DESCRIPTIVE REPORT

Registry No. H11335

General Locality Behm Canal

Sublocality Western Rudyerd Bay

Figure 1 – H11335 Survey Limits and Junctions

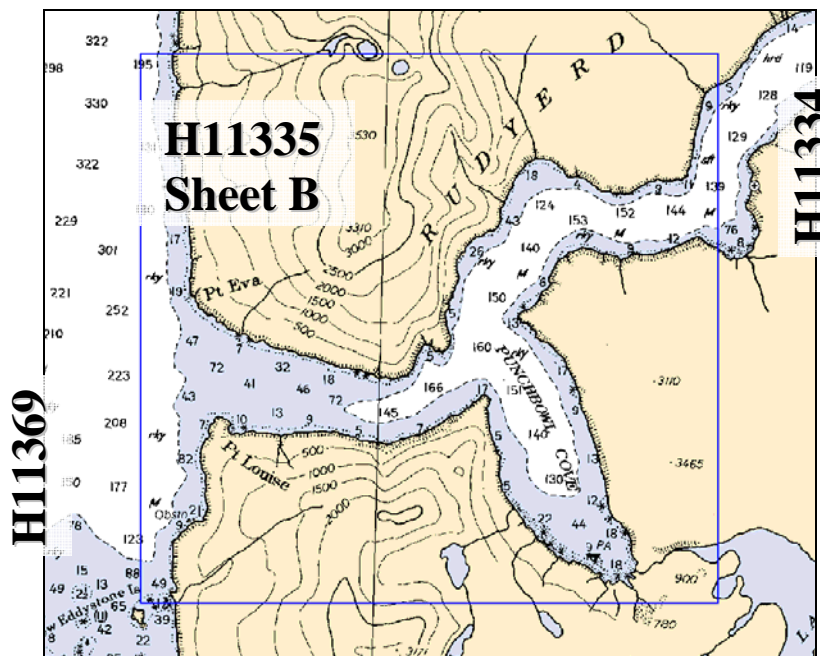
Survey H11335 junctions with surveys H11334 and H11369 (sheets A and C of this project, respectively – See *Figure 1*). The area of overlap between the sheets was reviewed in CARIS Subset Editor for consistency and data was found to be in good agreement to within one meter⁴.

⁴ Concur. H11334 and H11369 have been compiled to HCells. At the junction of HCell H11335 and H11334 a shoaler 19 fathom sounding will replace a 30 fathom sounding from H11334.
